# **Christmas Creek Expansion Public Environmental Review – Response to Public Submissions**

**Christmas Creek**

**25 September 2015  
CC-RP-EN-0120**

Figure 1 – Fauna Habitats

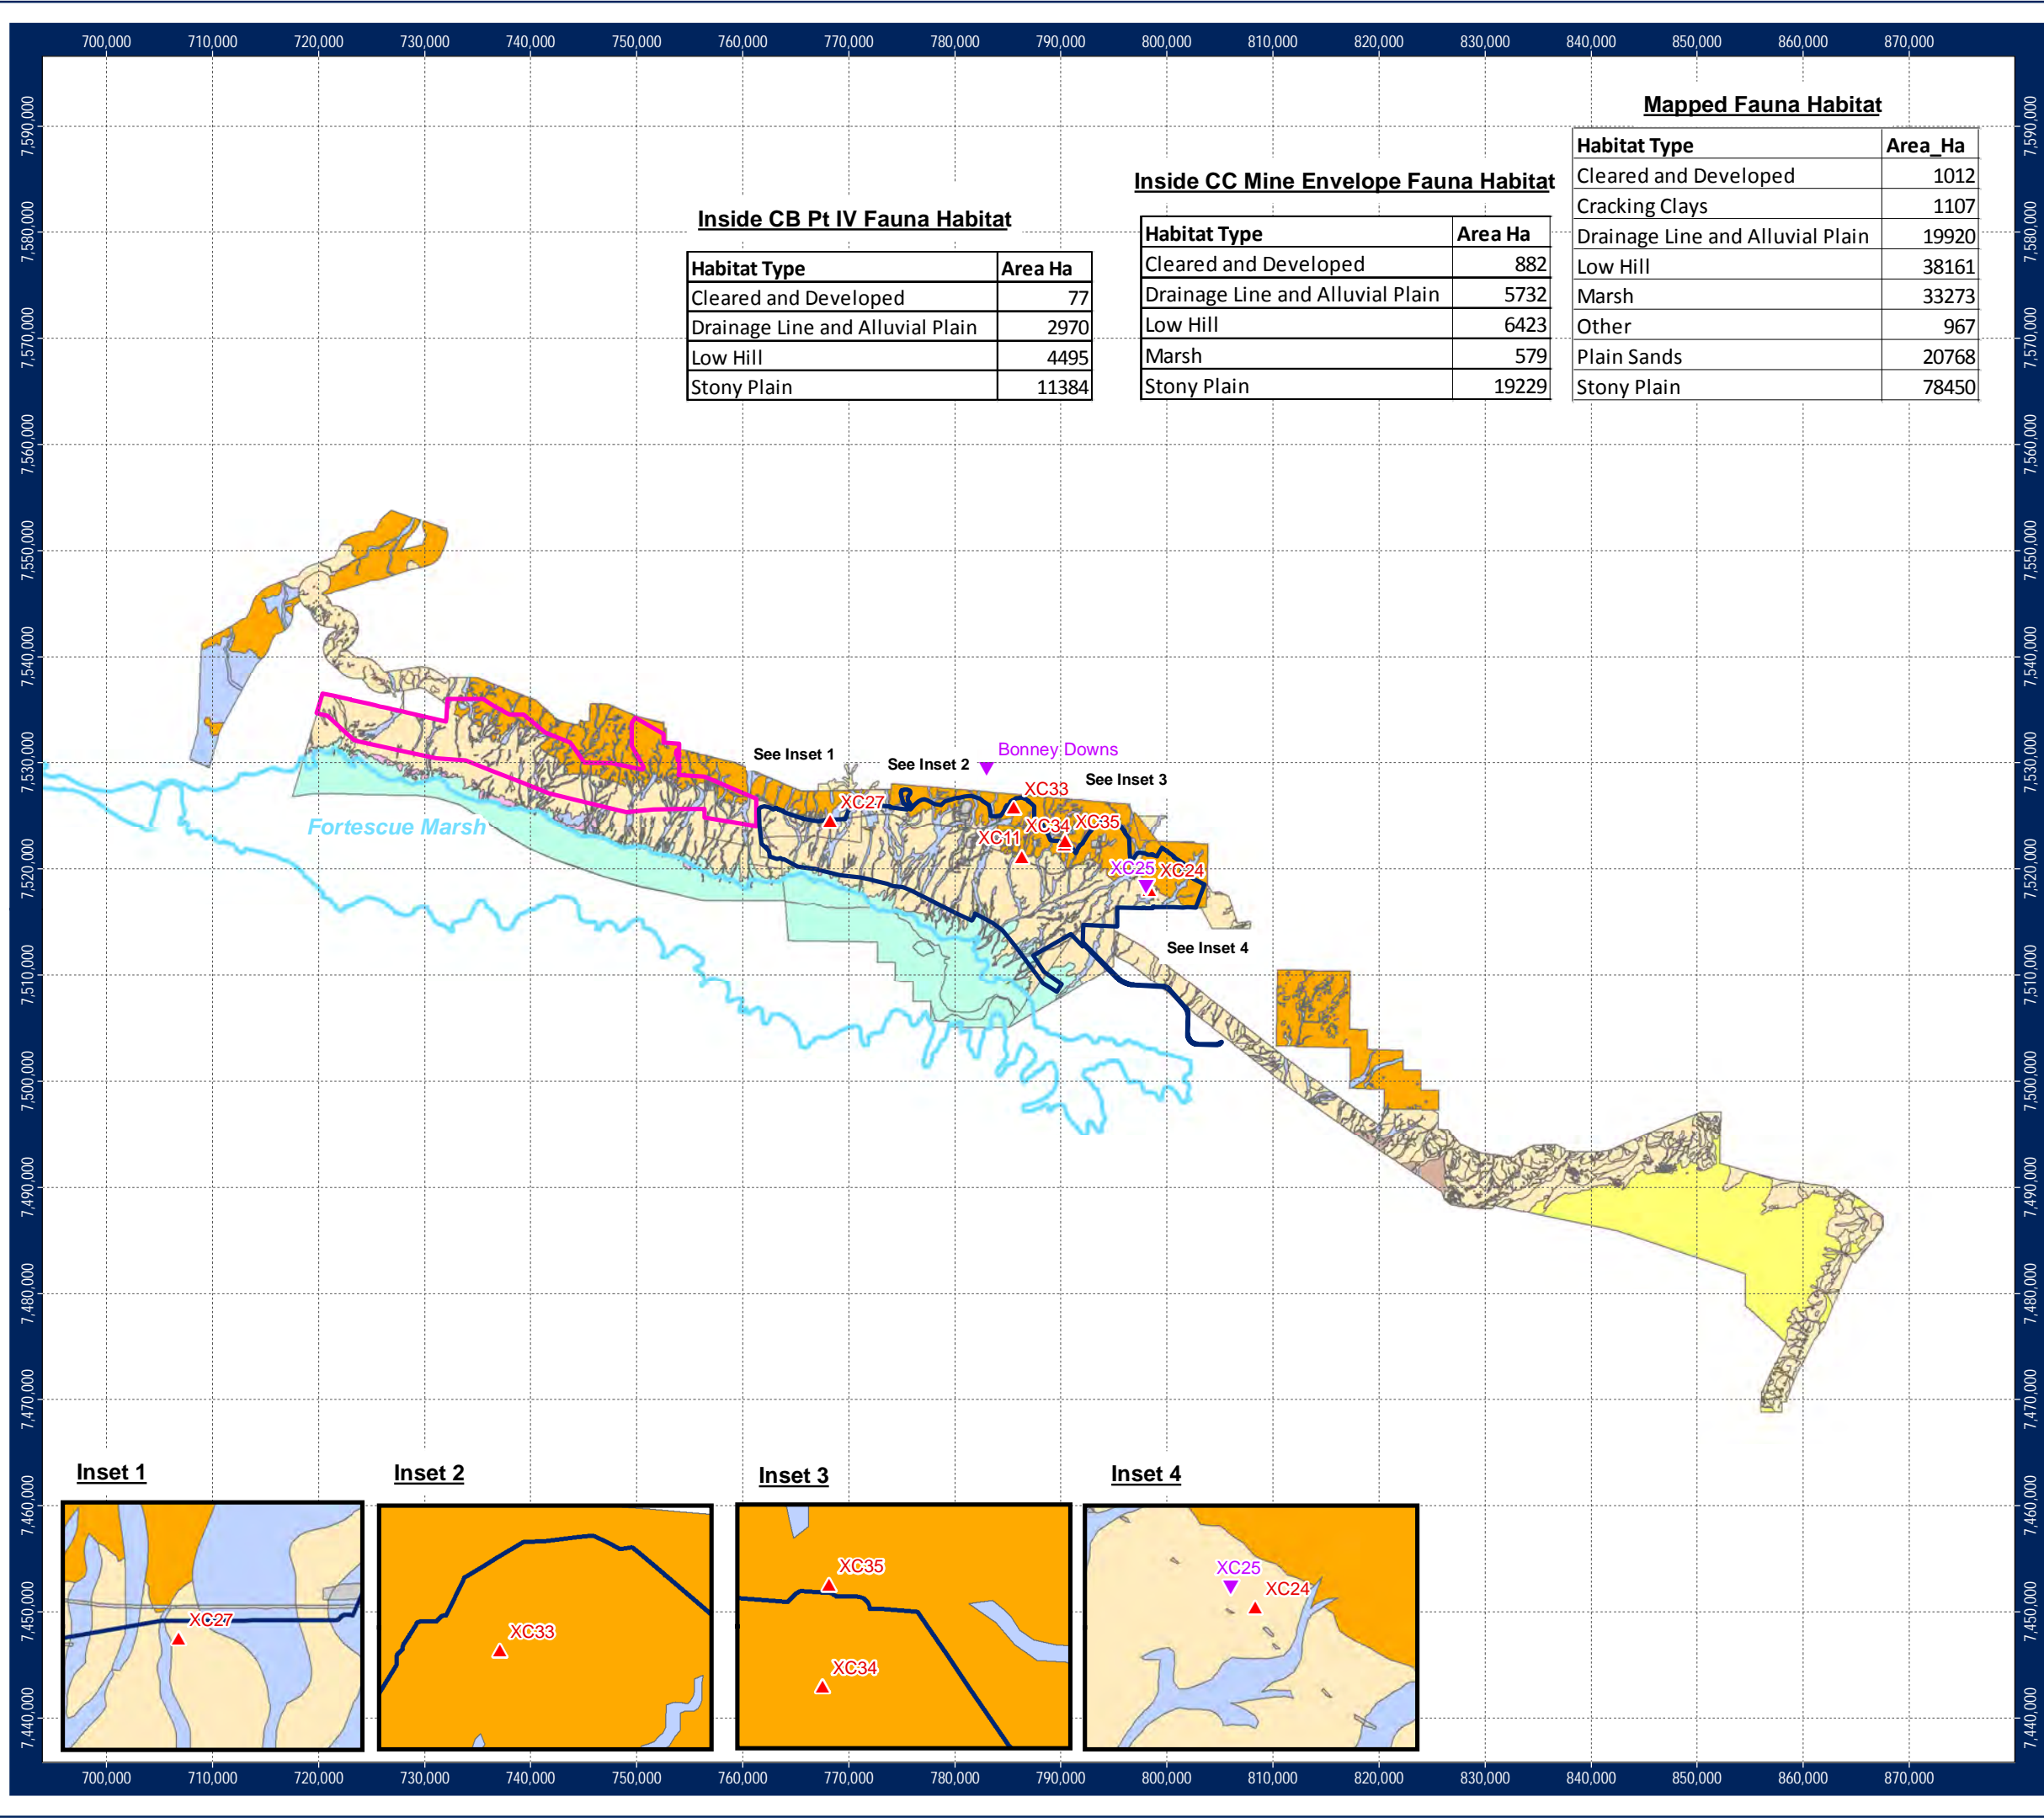
1.4	<p>Cumulative impacts</p> <p>The PER states that terrestrial fauna 'habitats occur in the wider region and cumulative impacts are not expected to have significant impacts on the distribution and abundance of [terrestrial] fauna species'. As cumulative impacts to terrestrial fauna have not been quantified there is no evidence to support this statement. Therefore, it is difficult to confidently identify and predict any cumulative impacts.</p> <p>Please provide quantitative data, as per the ESD, to predict the cumulative impacts to fauna habitat, by incorporating the known or predicted impacts on fauna habitats in the context of the Cloudbreak, Christmas Creek and Roy Hill proposals.</p>	<p>Fortescue has compiled Figure 1 (CC_MP_EN_0265_r3) to summarise the extent of the fauna habitats mapped (by Fortescue) across the Chichester Ranges in the vicinity of the Proposal.</p> <p>Table i summarises the habitats mapped and the habitat types within the Cloudbreak and Christmas Creek development envelopes. Fortescue is unable to obtain details on the quantity of each habitat unit within the boundaries of the RHIO development from the relevant PER document or subsequent EPA reports. The lack of data is balanced by the Fortescue mapping (Figure 1) which excludes the majority of the RHIO development boundary.</p>

Figure 2 - Potential SRE Habitat

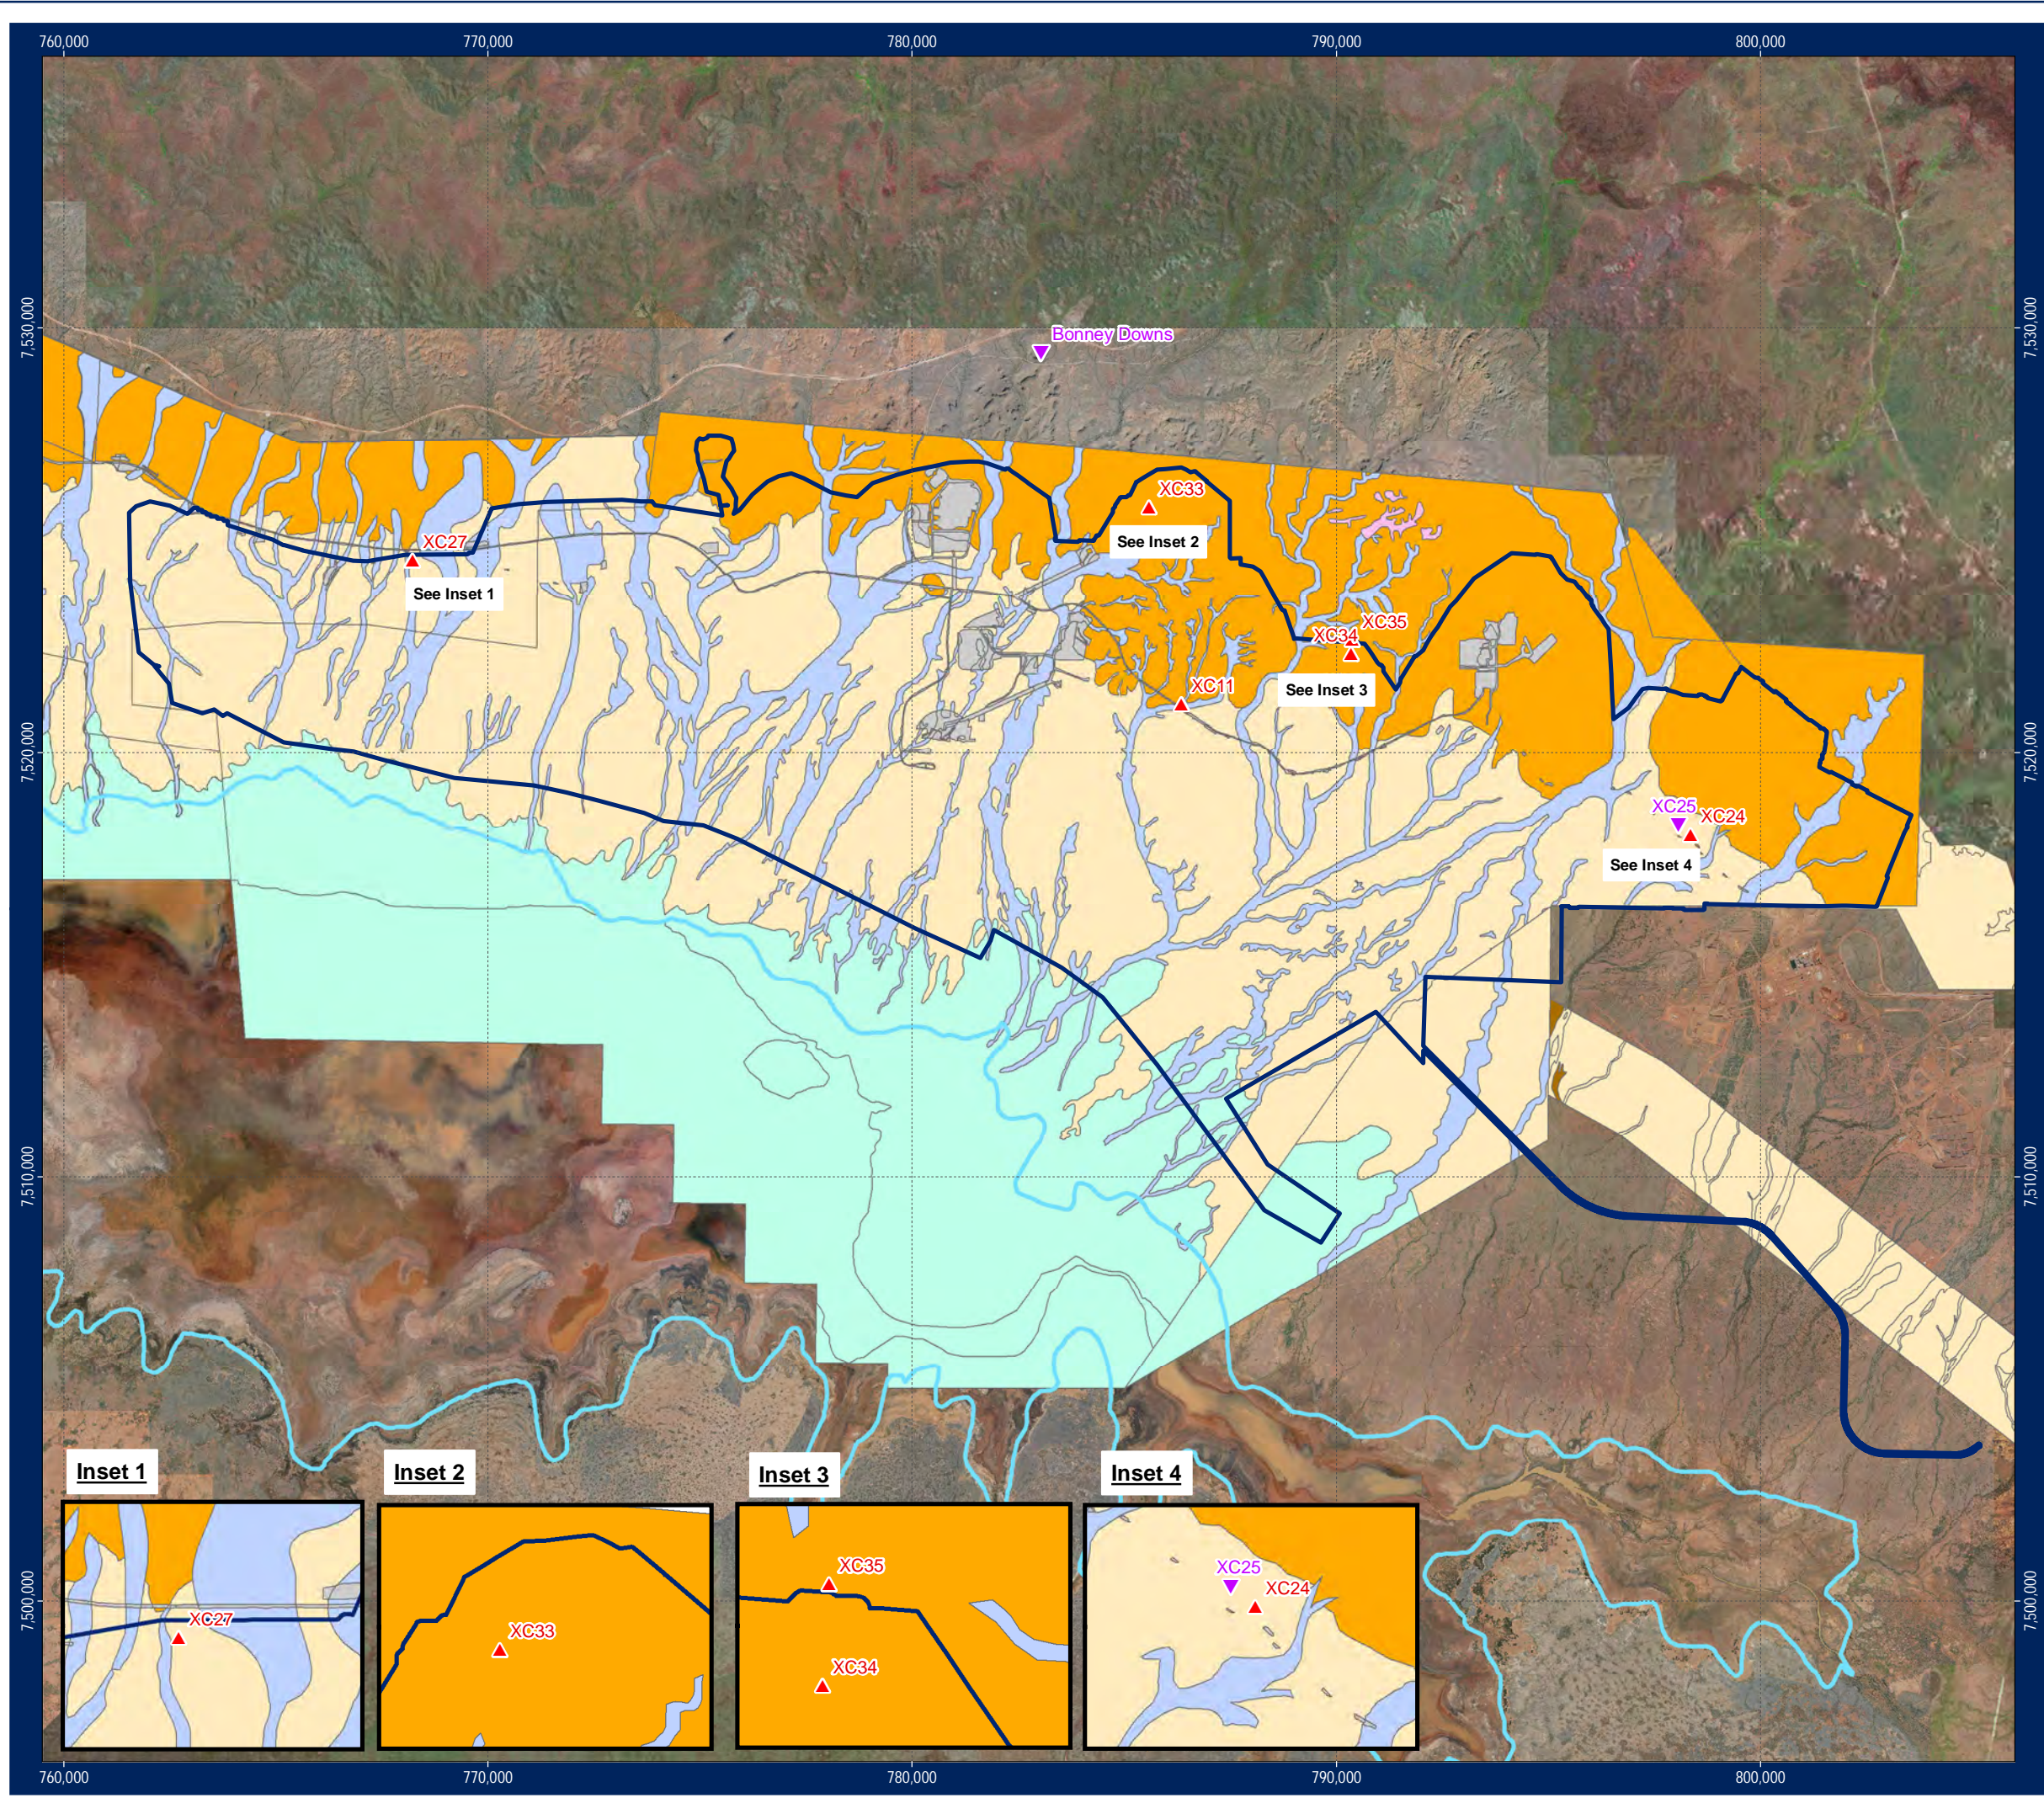
1.7	<p>Short Range Endemic (SRE) species</p> <p>Impacts to SRE invertebrate fauna include the potential for impacts to the millipede <i>Antichiropus</i> sp. 'Christmas', which has only been identified from the existing and proposed mine pit areas. Although this species has been found in three habitat types that are widespread in the region (Figure 13 Subterranean Ecology 2012), there is the potential for cumulative impacts to this species and its habitat when adjoining proposals are considered. The management of SRE invertebrate fauna should be consistent with that for neighbouring proposals including the implementation of exclusion zones and monitoring (for example see Ministerial Statement 824 Roy Hill 1 Iron Ore Mining).</p>	<p>Fortescue does not consider it necessary to undertake further monitoring of SRE species or establish exclusion zones with the Christmas Creek Development Envelope as the two potential SRE species identified within the Proposal are found outside of the development envelope boundary.</p> <p>Fortescue has prepared the attached Figures 1 and 2 to demonstrate the location of the potential SRE species identified and the distribution of habitat (mapped by Fortescue) across the broader region.</p> <p>As detailed on page 181 of the PER the potential SRE spider <i>Karaops</i> sp. 'Christmas' is considered to inhabit cracks and crevices in rocky outcrops, or under the bark of trees. The specimen located at site XC25 was found within a habitat consistent with the 'Stony Plain' habitat unit. An additional specimen was identified in a previous survey at Bonney Downs over 18 km north west of the Christmas Creek site.</p> <p>In Figure 1 Fortescue has mapped over 78,000 ha of Stony Plain habitat in the vicinity of the Chichester Ranges. The PER indicates 4,366 ha of the habitat will be disturbed by the Proposal. Additionally 11,384 ha of the mapped habitat is within the neighbouring Cloudbreak mine development envelope.</p> <p>Although the Bonney Downs specimen is outside of Fortescue's habitat mapping it is understood the specimen was located within the "Low Hill" habitat unit. Fortescue has mapped over 38,000 ha of Low Hill habitat, with over 27,000 ha of this area located outside of the Christmas Creek and Cloudbreak mine development envelopes. The aerial imagery detailed in Figure 2</p>

Item	OEPA Comment	Proponent Response
		<p>indicates the 'Low Hill' habitat extends further northwards outside of the areas mapped by Fortescue.</p> <p>Fortescue considers there is sufficient habitat for <i>Karaops</i> sp. 'Christmas' outside of the areas indicated to be disturbed by the proposal to eliminate the requirement for exclusion zones. Additionally with a specimen identified from a previous survey at Bonney Downs, Fortescue considers the likelihood of the potential SRE species being well distributed outside of the proposal area as high.</p> <p>Map inserts 1 – 3 of Figure 2 illustrate the locations of the <i>Antichiropus</i> sp. 'Christmas' in relation to the Christmas Creek Development Envelope boundary. Map insert 3 details that site XC 35 is located approximately 30 m outside of the development envelope and is not proposed to be disturbed during implementation of the Proposal.</p> <p>Appendix 7B of the <i>PER Christmas Creek Life of Mine Project SRE Invertebrate Survey</i> describes the habitats associated with the locations of specimens of <i>Antichiropus</i> sp. 'Christmas' were collected from (section 8.4). The habitats include Drainage Lines and Alluvial Plains and Stony Plains, and these habitats are abundant within the area mapped in Figure 1.</p> <p>Map Inserts 1, 2 and 3 of Figure 2 detail the close proximity of the specimen locations to the development envelope boundary (XC27 140 m, XC 33 500 m and XC34 300 m). The inserts also illustrate the continuation of the habitat associated with specimen location outside of the development envelope.</p> <p>Fortescue considers there is sufficient habitat for <i>Antichiropus</i> 'Christmas' outside of the areas indicated to be disturbed by the proposal to eliminate the requirement for exclusion zones. Also given the potential SRE species was collected widely across the survey area in most SRE habitat types Fortescue considers the likelihood of the species being abundant outside of the development envelope as high.</p>
